ELECTRICAL SAFETY INSPECTION REPORT

INTERFAB SHIRT MANUFACTURING LTD (UNIT-2)

Inspected on: July 28, 2019

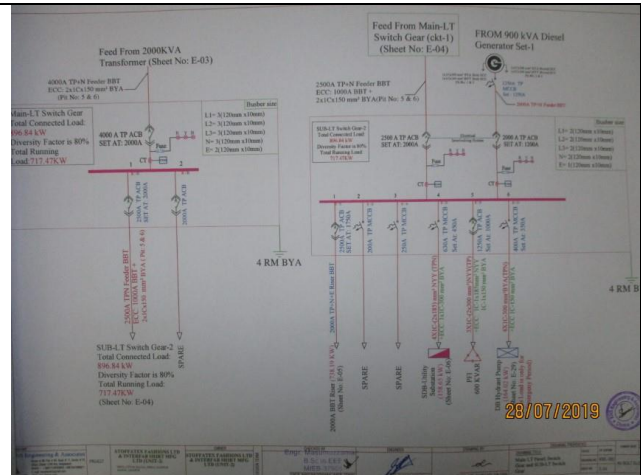
FINDING NO:	E - 1
CATEGORY:	DOCUMENTATION
FINDING: SLD is not amended properly (busbar dimension, connecting busbar rating from main bus to MCCB and load details missing).	
RECOMMENDATION: Draw as built electrical SLD mentioning all required information by qualified engineer and get it reviewed by Accord. Electrical SLD must be updated properly when electrical system is modified.	
PRIORITY:	P2
REMEDIATION TIME FRAME:	3 MONTHS
